Final Report for the December 2013 Targeted Performance Improvement Visit at the City of Wichita Fall Cypress Street 2010 Water Treatment Plant

Executive Summary

Technical Summary

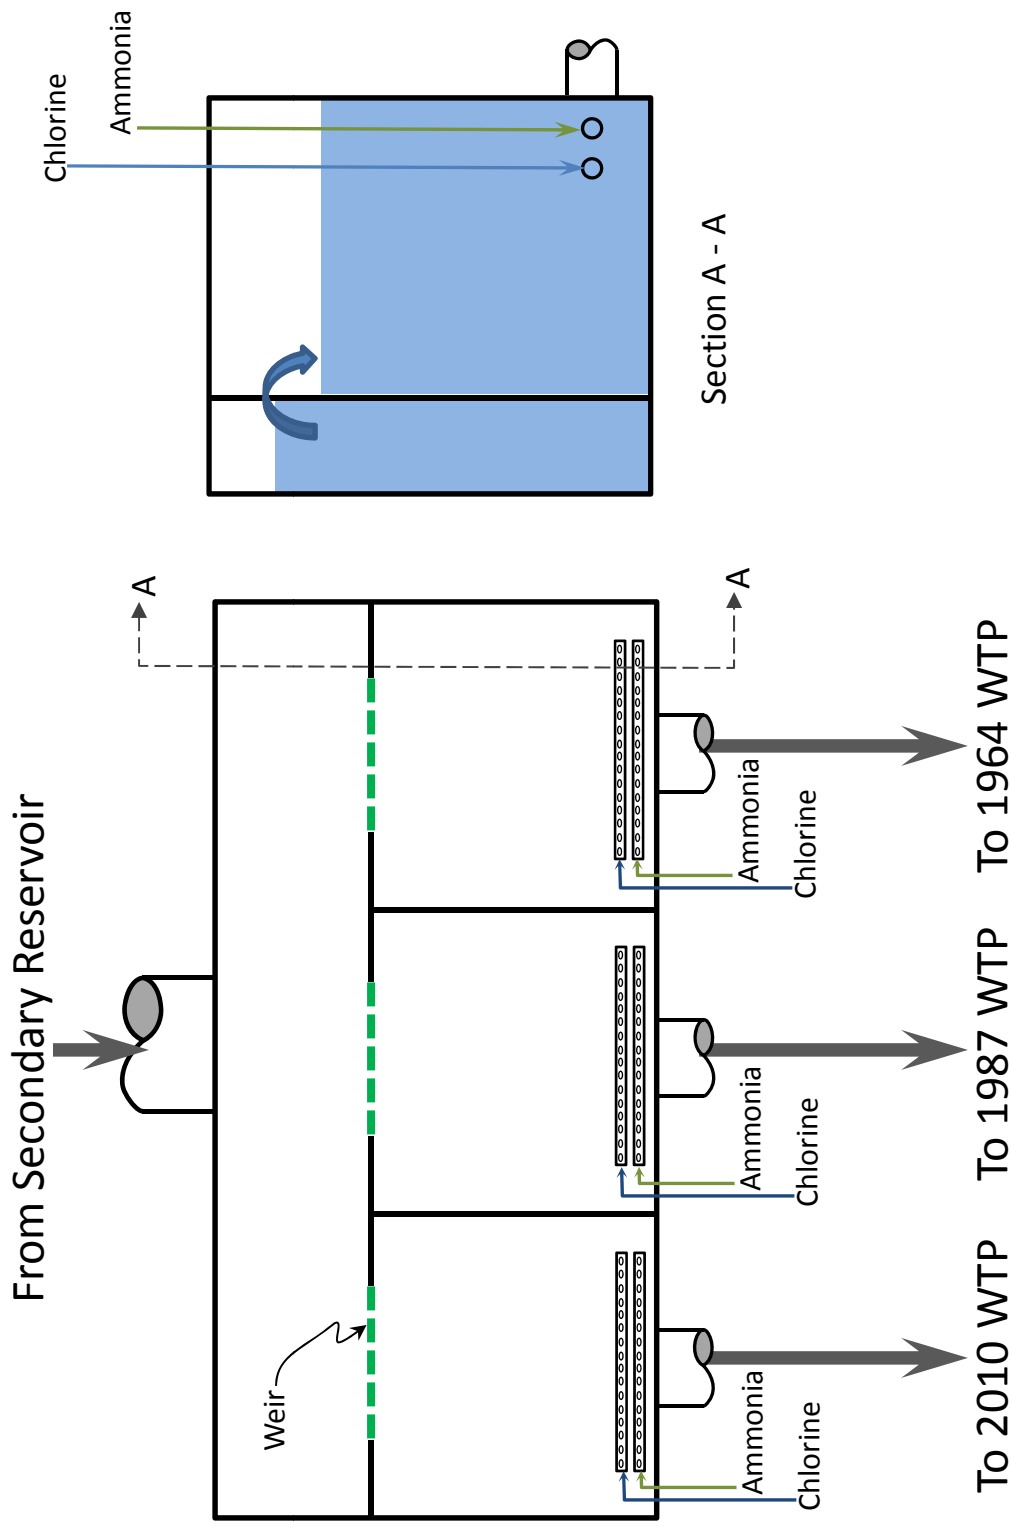
- a) The chlorine and ammonia injection points at the 2010 WTP splitter box are located too close to one another to ensure that all of the water passing through the splitter box will be exposed to free chlorine before it is exposed to ammonia. (see Attachment 1)

The CT requirements for chloramine, the 2010 WTP's primary disinfectant, are based on the assumption that all of the water being treated with chloramine has been exposed to free chlorine, chlorine dioxide, or ozone prior to treatment with chloramines. As a result, the City will need to:

- i) maintain a detectable chlorine dioxide residual in the raw water line from the secondary reservoir at all times, or
 - ii) redesign the chlorine and ammonia injection points to ensure that all of the water is exposed to free chlorine before ammonia is injected, or
 - iii) increase the chloramine contact time or the chloramine residual so that the plant can provide additional viral inactivation as a safety factor to replace the safety factor achieved if alternate disinfectants are used.
- b) The Combined Filter Effluent (CFE) monitoring site for the 2010 WTP plant is located at the Cypress Street high service pump station rather than at the 2010 WTP filtered water transfer pump station. Consequently, the 2010 Plant's CFE turbidity levels are not measured before the
